Hi-Fi Products
Service Bulletin

Model: D-2/4/11/12/33/34/36/180K/802K/T2/
T4/T24

No. 285R1

Subject: Replacement Gear Available For Sled Motor Gear Train **Date:** February 10, 1992

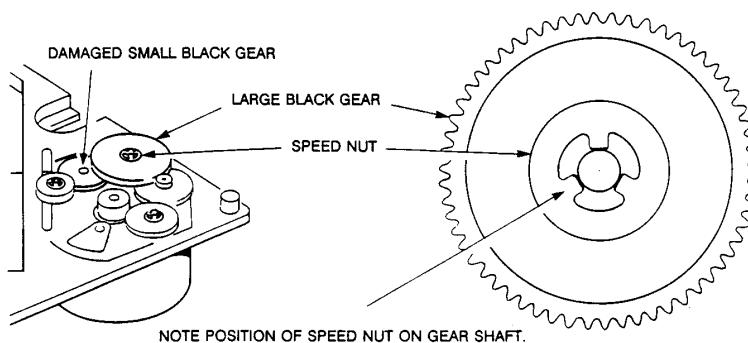
Symptom:
(**)

Previously, if the small black gear located beneath the large black gear was damaged, the entire chassis had to be replaced.

A kit is now available which allows replacing the damaged gear without having to replace the chassis. Follow the procedure below when replacing the gear.

1. Take note of how the speed nut is mounted on the shaft for the large black gear, then remove the nut, large black gear, and the damaged small black gear.
2. Remove the wire spring and replace with the one included in the kit.
3. Install the new gear included with the kit.
4. Reinstall the large black gear.
5. Carefully install the new speed nut included in the kit in a position rotated 60° from the original position.
